DART AEROSPACE LTD	Work Order:	23311
Description: Console Side LH (206 Hi-Slope)	Part Number:	D2602-1
Note: Issue with Part Number D2602-2		
Dwg: D2602 Rev. A1	Qty:	5 10
		Page 1 of 1

DESIGN	DRAWN BY	DART AEROSPACE LTD VICTORIA INTERNATIONAL AIRPORT, CANADA	
CHECKED	APPROVED	DRAWING NO.	REV. A
KE	JS	D2602	SHEET 1 OF 1
DATE	TITLE		
97.10.22	CONSOLE SIDE		
A	97.10.22	D2602 WAS D206-547-21 / -22	1:4
AI	02.06.04	ADD FINISH

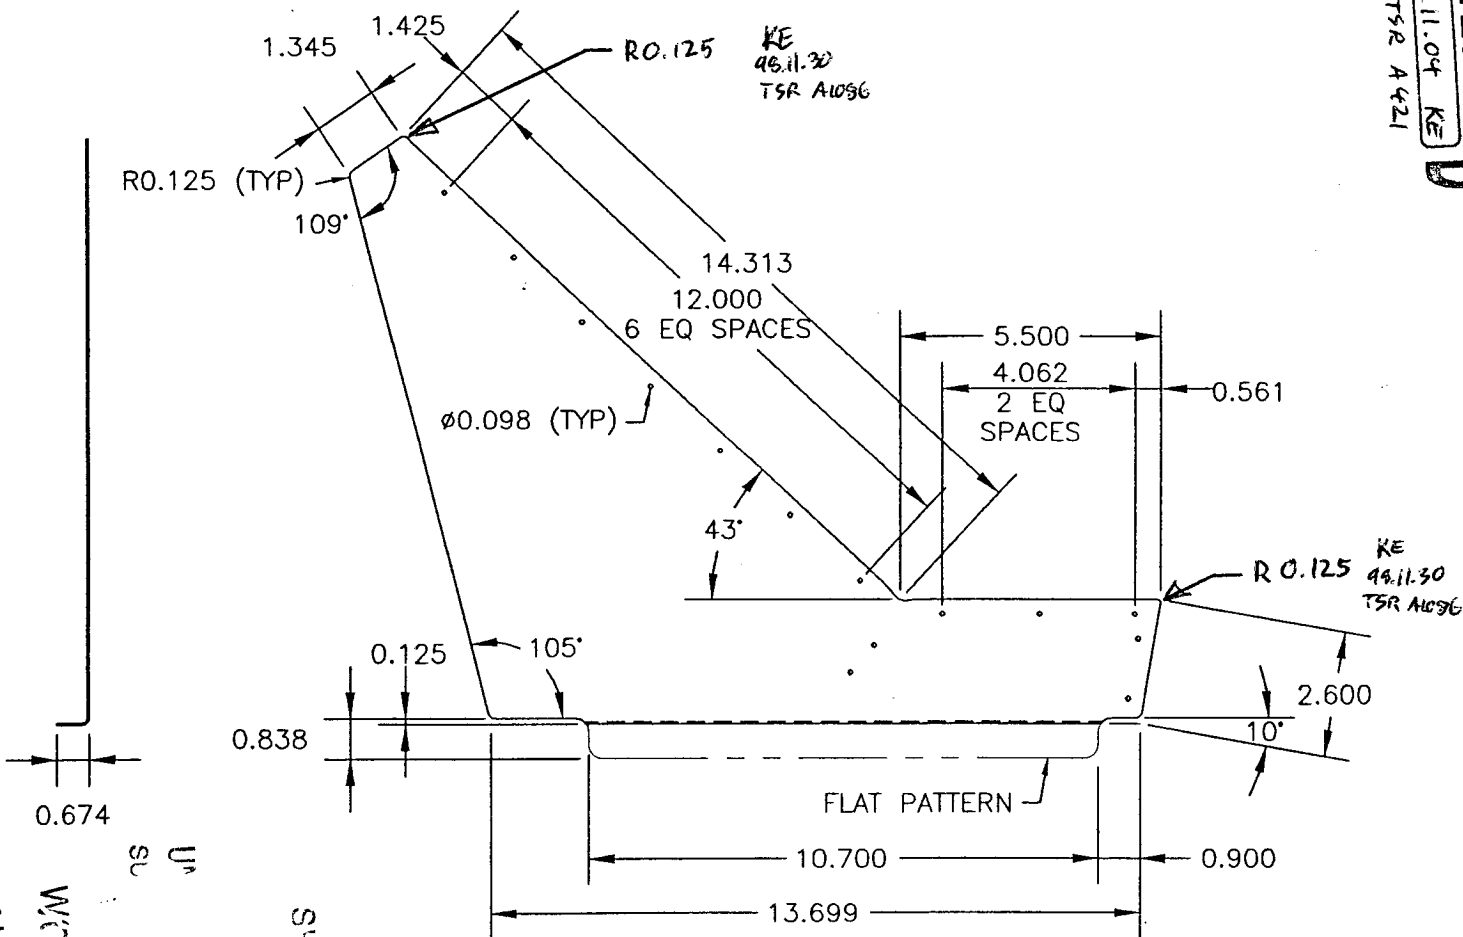
NCR: 233113		WORK ORDER NON-CONFORMANCE (NCR)						
DATE	STEP	Description of NC Section A	Corrective Action Section B			Verification Section C	Approval Design Mgr	Approval QC Inspector
			Initial Design Mgr	Action Description Design Mgr	Sign & Date			
05-06-20	3	5x 02602-1 folio not clear for dowel pin location. Parts machined to high up and bottoms came up short		Scrap: destroy Ensure dowel pin location is clearly indicated from folio to base plate	 05.06.20	 05.06.20	 05.06.20	 05-06-20
